PLANNING REPORT

RE: KRE Acquisition Corp.

100 Deforest Avenue
Block 42, Lots 37, 37.02, 38, and 41
Review Letter #5¹
Project No. EHB-087

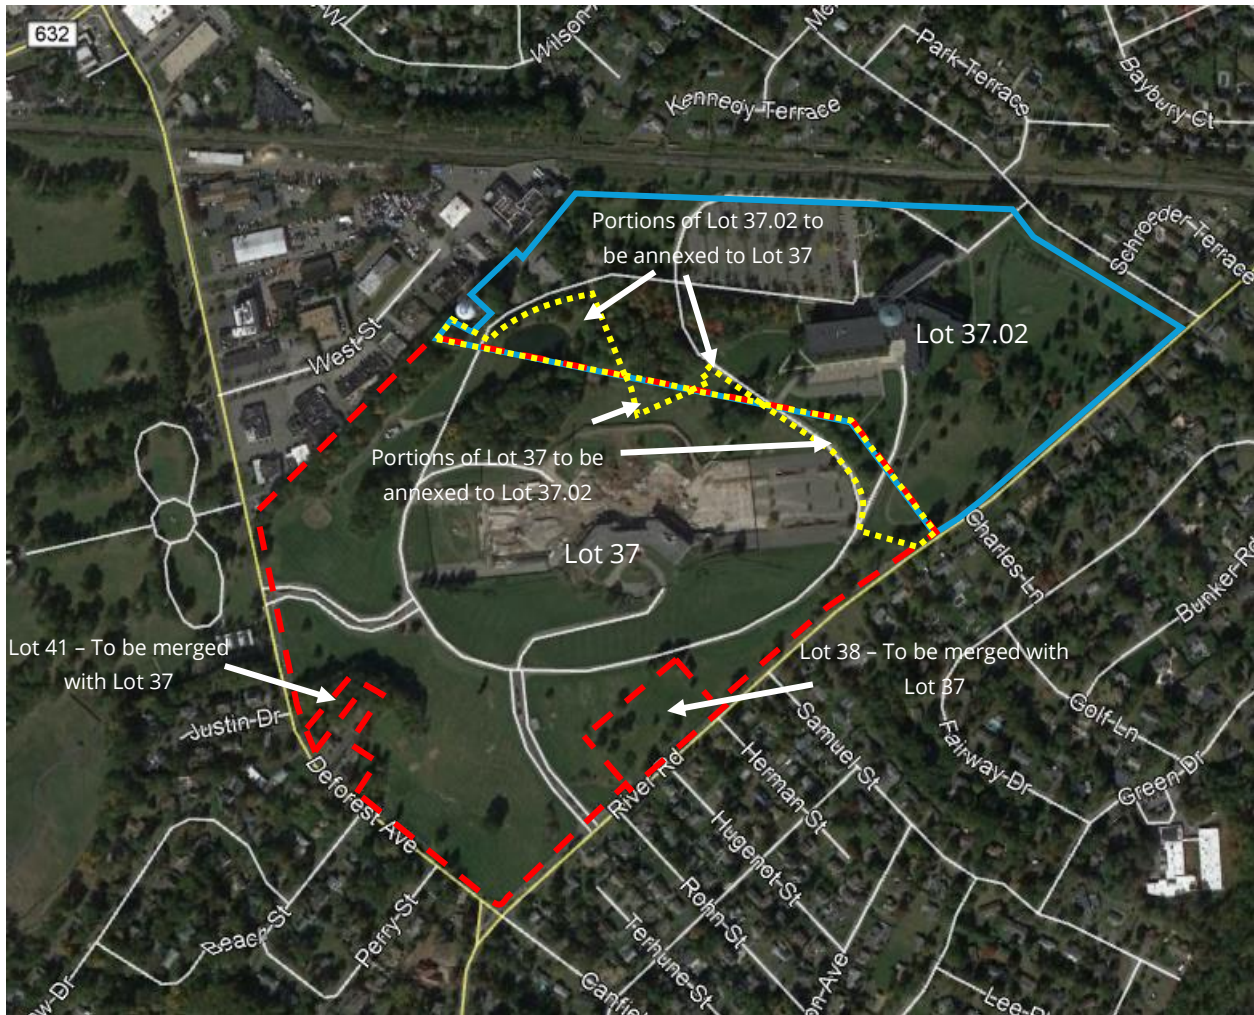
Most of the property is in the RMF, Residential Multi-Family Zone. A small portion of the site would be in the R-L Research Laboratory and Office Zone if the subdivision is granted. The site is adjacent to office and industrial uses to the northwest, the Mondelez International, Inc. "Technology Building" to the northeast, and single-family dwellings to the east, across River Road, and south and southwest, across Deforest Avenue. A cemetery is also located to the southwest across Deforest Avenue. See the image on the following page for the general location of the site.²

Note that the existing property lines of Lots 37, 38, and 41 are shown in red, the existing property lines of Lot 37.02 are shown in blue, and the proposed minor subdivision line between the two existing lots is shown in yellow.
